**SECTION 16 APPLICATION
TOWN PLANNING ORDINANCE (CHAPTER 131)**

Town Planning Application No. A/YL-NSW/348 - Submission of Further Information (7)

Response-to-Comment Table

Figure Title **THE WALKING PATH BETWEEN THE PROPOSED RCHD AND THE NEARBY FRANCHISED BUS STOPS**

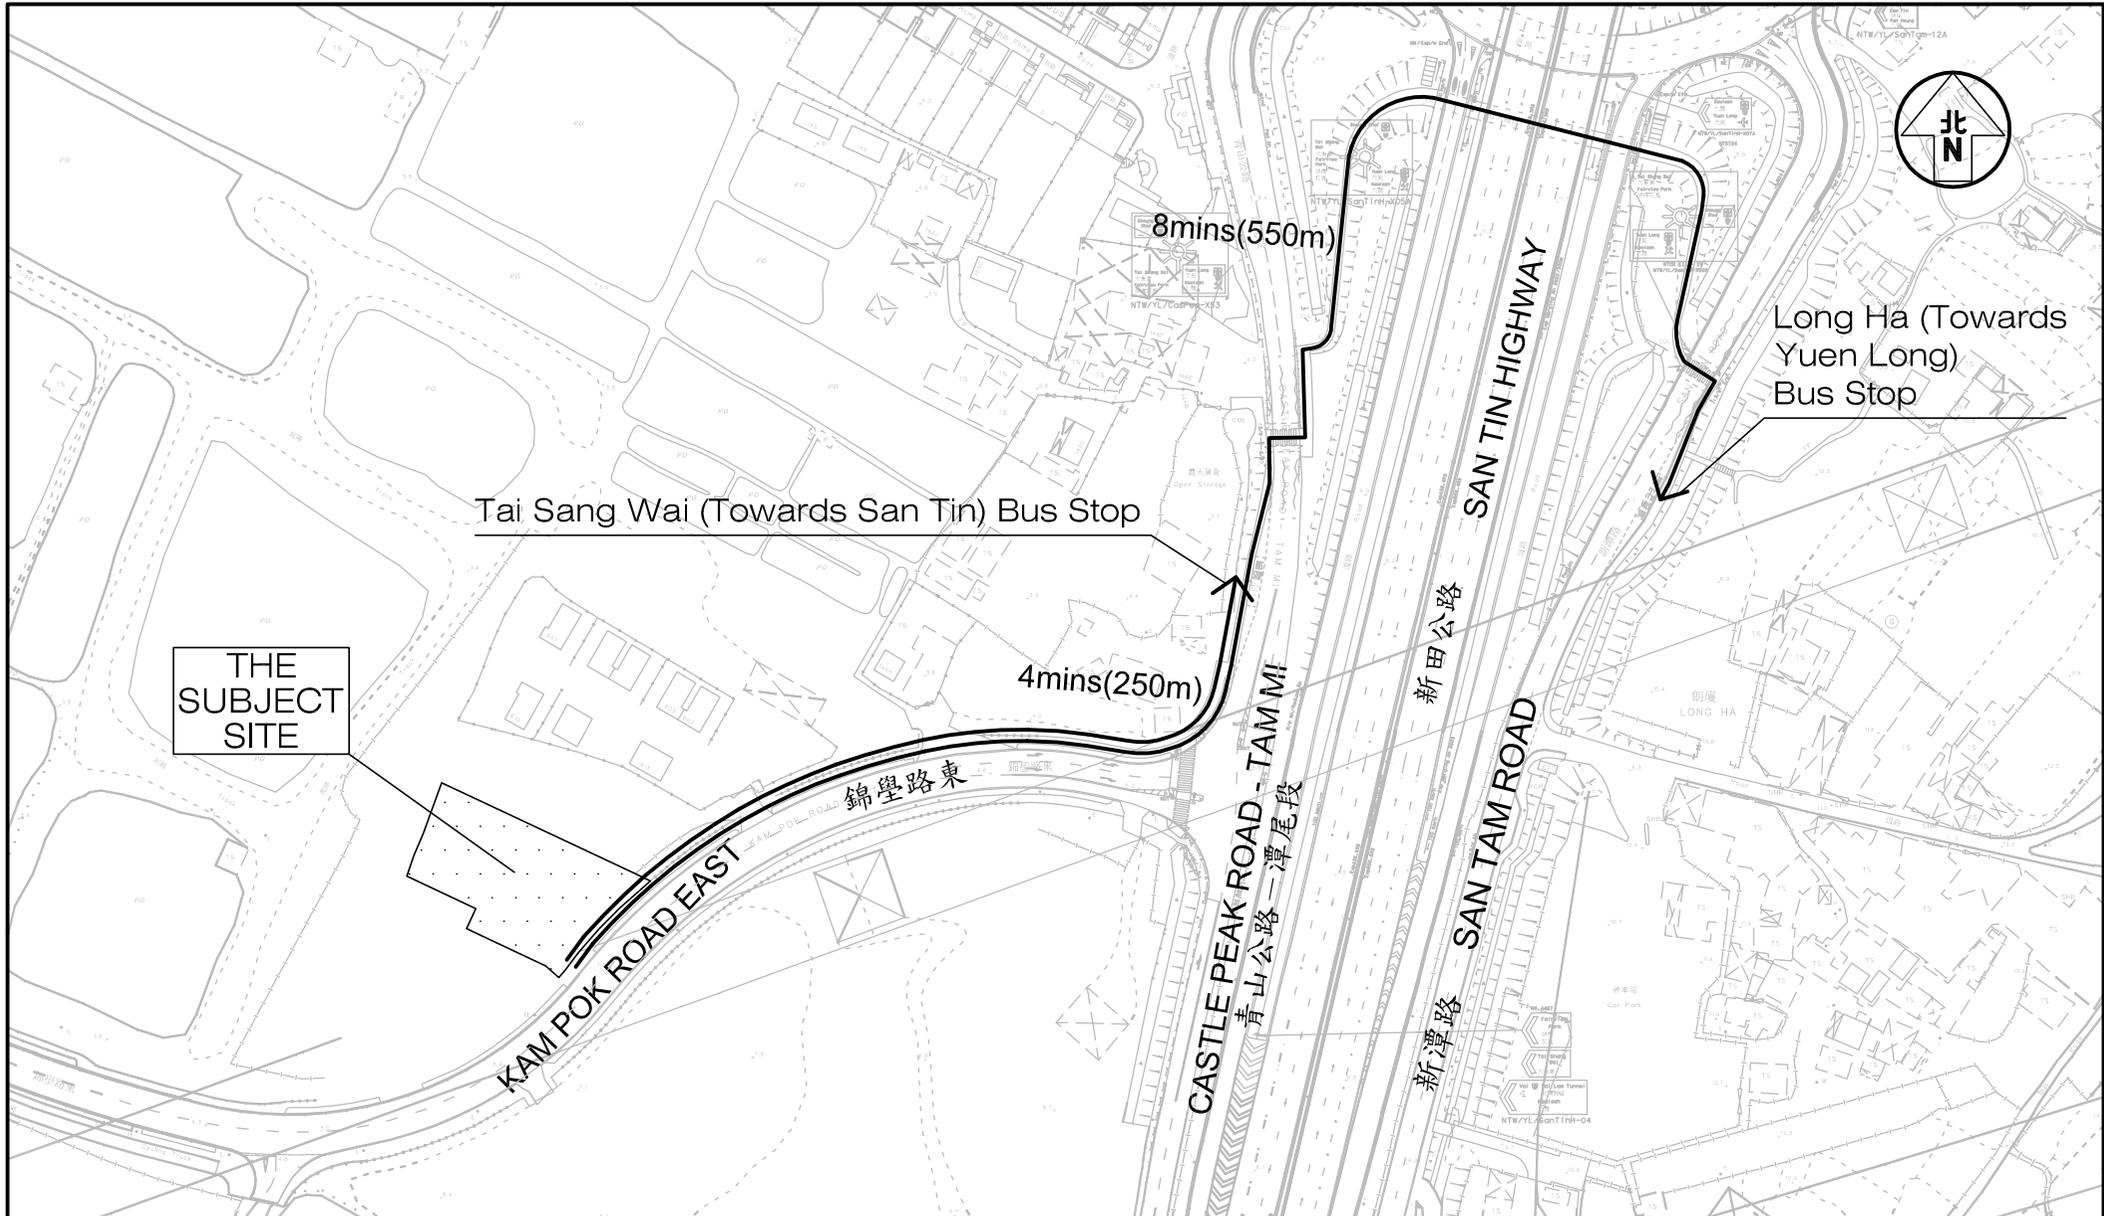
12. Please provide a plan showing the pedestrian routing to the nearby franchised bus stop (both Yuen Long and Sheung Shui bound). Please specify the corresponding walking distance as well;	Noted. Please refer to Figure 2.7 in the revised TIA for the pedestrian route to the nearby franchised bus stops.

Figure Title **G/F LAYOUT PLAN**

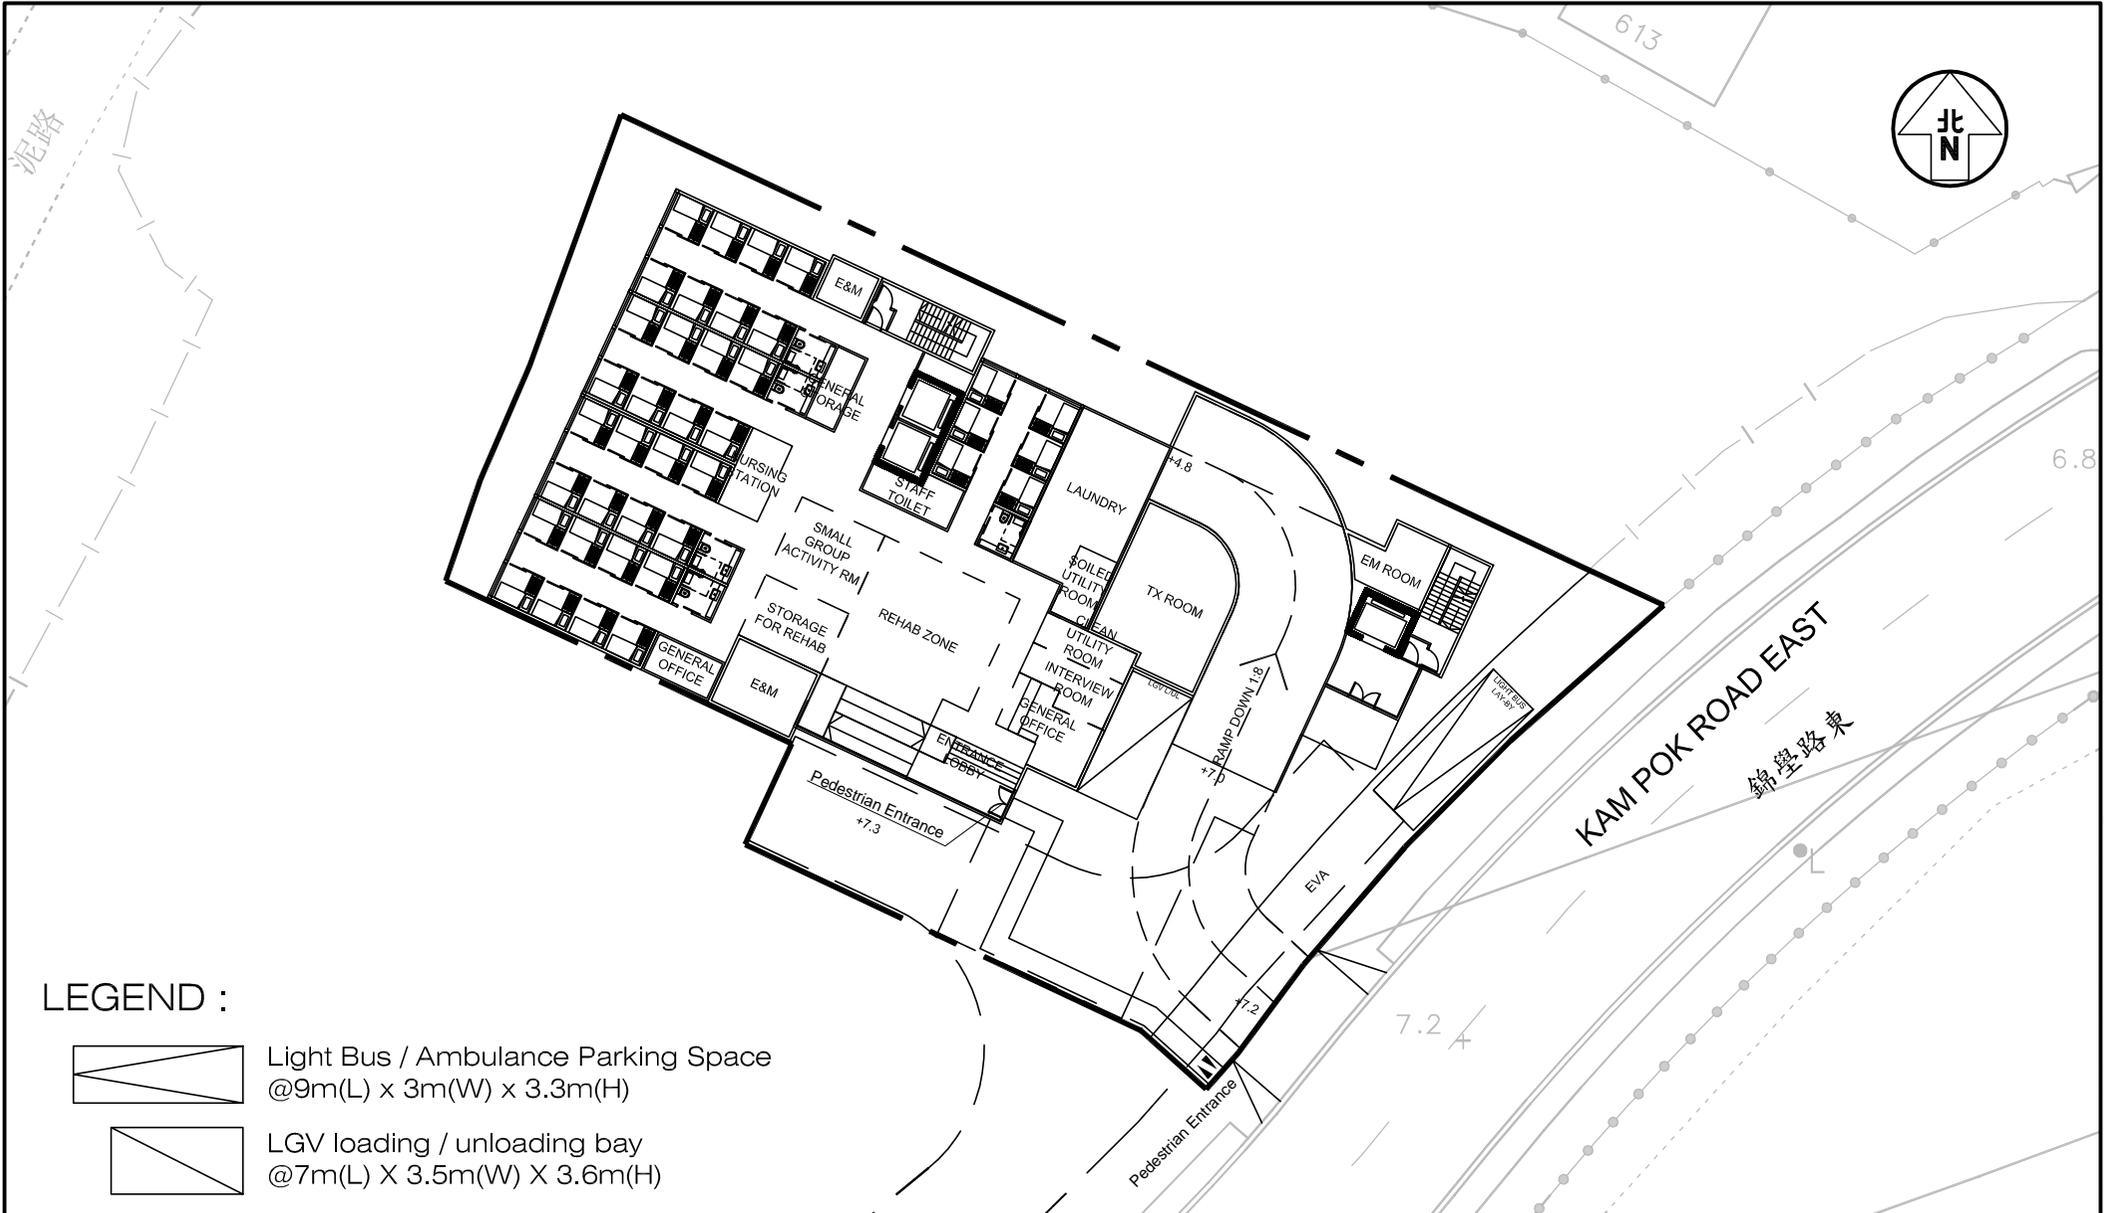
12. Re. RtC item 11: In the site entrance, please provide a clear segregation between vehicles and pedestrians from road safety perspective. For the proposed pedestrian entrance in the building in Figure 3.1, apparently pedestrian is expected to walk across the vehicle manoeuvring area (i.e. car lift, light/ambulance, LGV, PCs/taxis) which poses a safety concern. Please review.

Pedestrian entrance provided for the Proposed RCHD is separated from the manoeuvring area. Please refer to the **Figure 3.1** in the revised TIA.

Figure No.	3.3	Revision	C
Designed by	C Y Y	Drawn by	N C M
Checked by	K C	Scale in A4	1 : 500
Date	03 OCT 2025

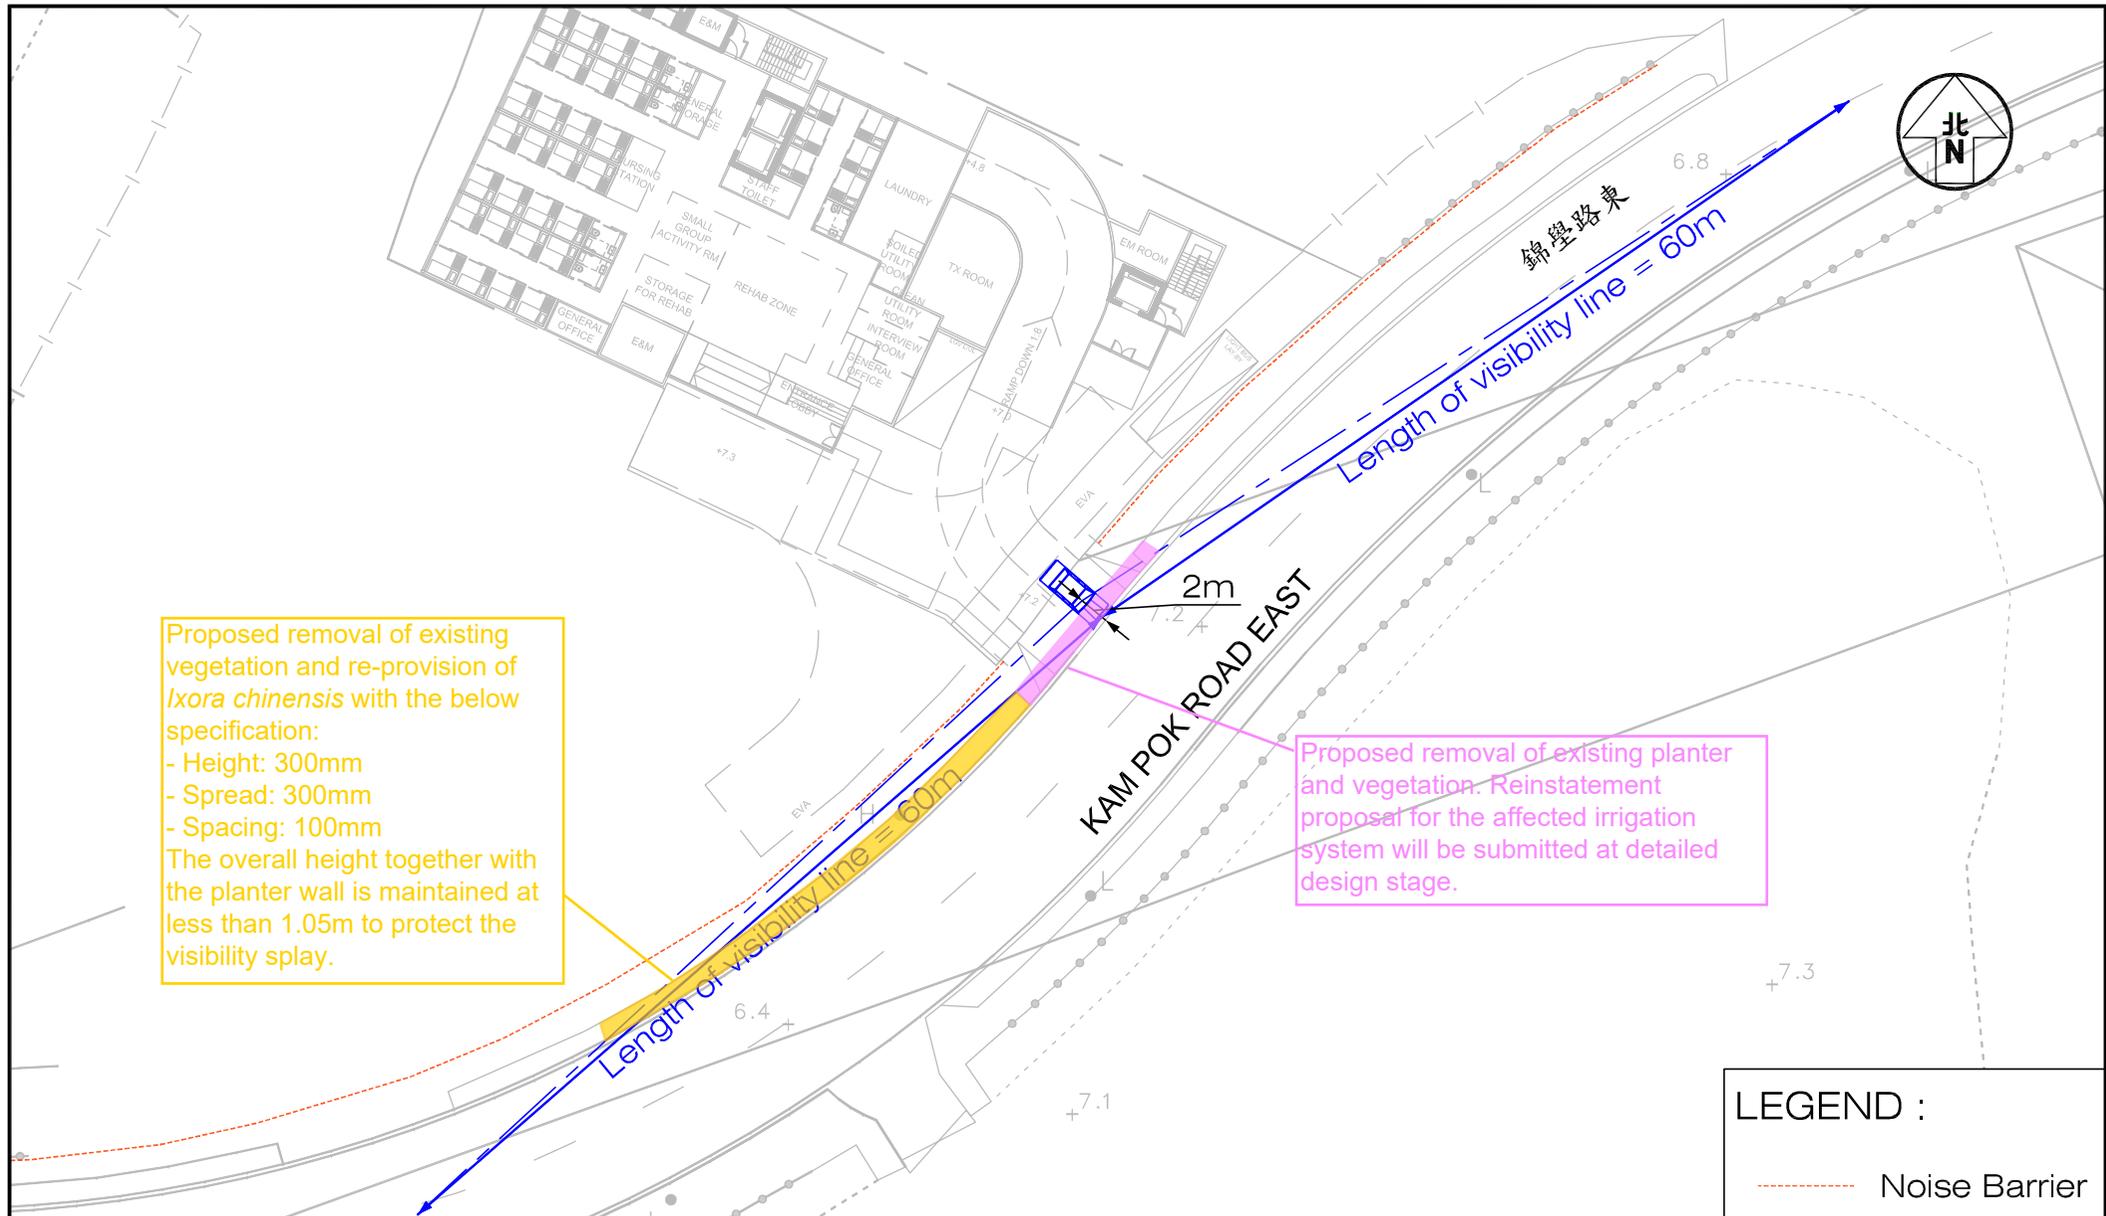
Departmental Comments		Responses
Email dated 26th January 2026:		
Comments from TD		
1.	Re. RtC Item 3: Please seek comment and agreement from the relevant management and maintenance party of the concerned planter area (HyD/LCSD) on your proposal of planter amendment (i.e. no planter taller than 1.05m would be erected within the visibility splay). Relevant record / consent from the management party of the planter shall be submitted to TD for record.	Preliminary agreement from HyD and LCSD has been obtained regarding the proposal of planter amendment. Please refer to Appendix 1 for the email correspondence with HyD and LCSD. Please also refer to Appendix 2 for the revised Figure 3.3 of TIA.

13. Re. RtC item 15: Please include the noise barrier on plan and revisit the visibility splay.

2. Given the congested area at the site entrance, the management staff should be on-site at all time to manage the traffic.	Noted.
3. Re. RtC Item 6: It appears that your checking of visibility splay has not taken into account of the existing planter. Please revisit the checking and demonstrate sufficient sightline could be maintained at all time since the commissioning of RCHE.	In order to ensure the adequate sightline for vehicles and pedestrian, the amendment of existing planter is needed to ensure no obstructions taller than 1.05m will be erected within the visibility splay at the run-in/out.

15. Please provide a plan to demonstrate sufficient sightline could be maintained at the proposed site access;	The measured length of visibility splay for the motorists leaving the Proposed RCHD is 60m to the left and 60m to the right, which is illustrated in Figure 3.3 in the revised TIA.

Noted. Please refer to the **Figure 3.3** in the revised TIA. The measured length of visibility splay for the motorists leaving the Proposed RCHD is 60m to the left and 60m to the right, so adequate sight line can be provided at the ingress/egress. The

Figure No. R1 Revision A

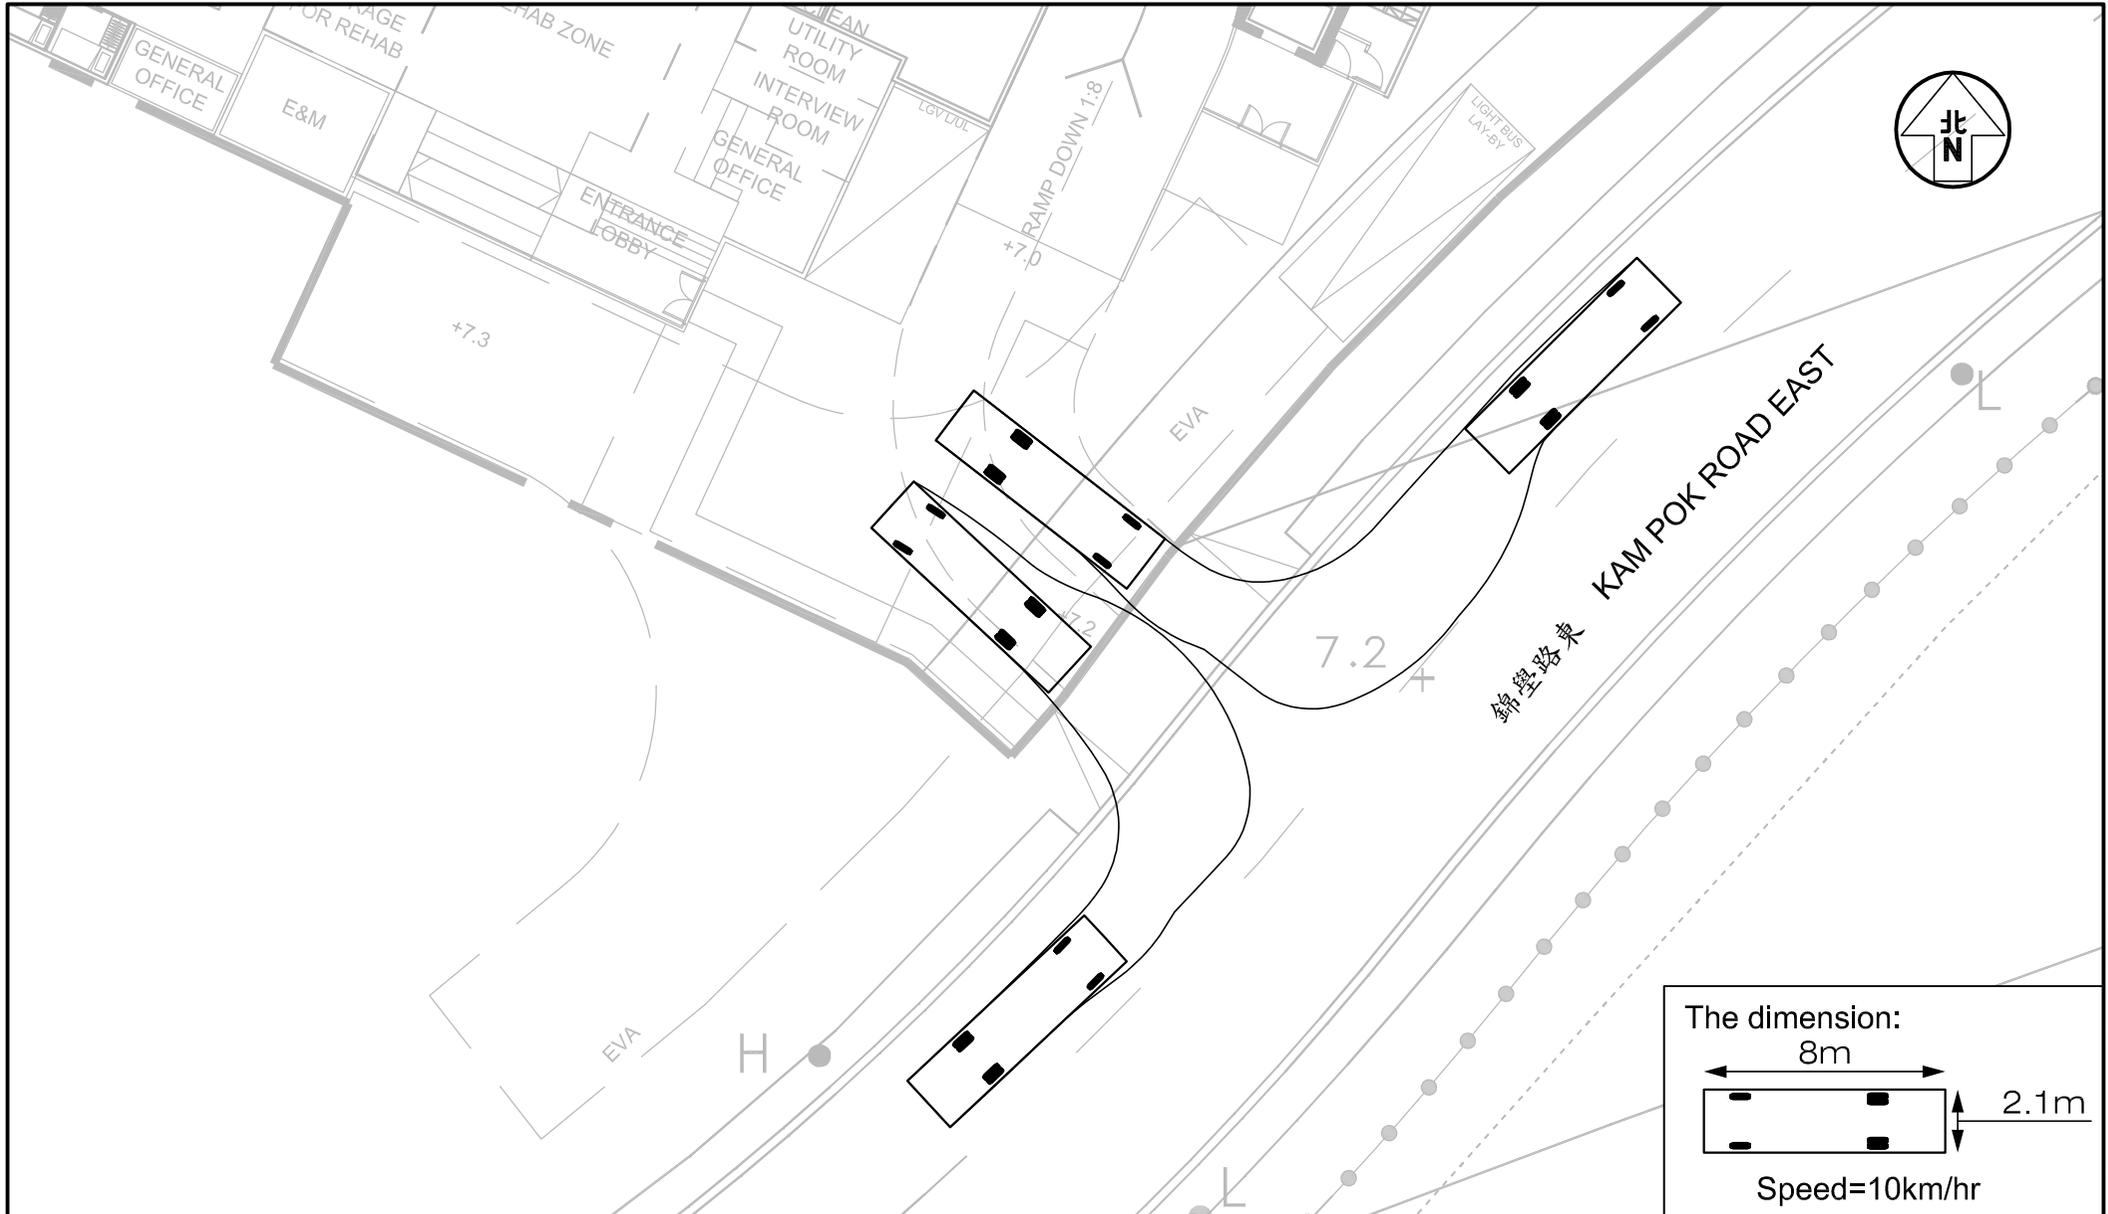
18. Please provide swept path analysis for the longest vehicle under this application to demonstrate no vehicle would encroach into the opposite lane when leaving the site.	The 8m-long Light Bus which is the longest vehicle expected to enter the Proposed RCHD can leave without encroaching into the opposite lane of Kam Pok Road East. Please refer to Figure R1 . [See Appendix 5 of the R-to-C table.]
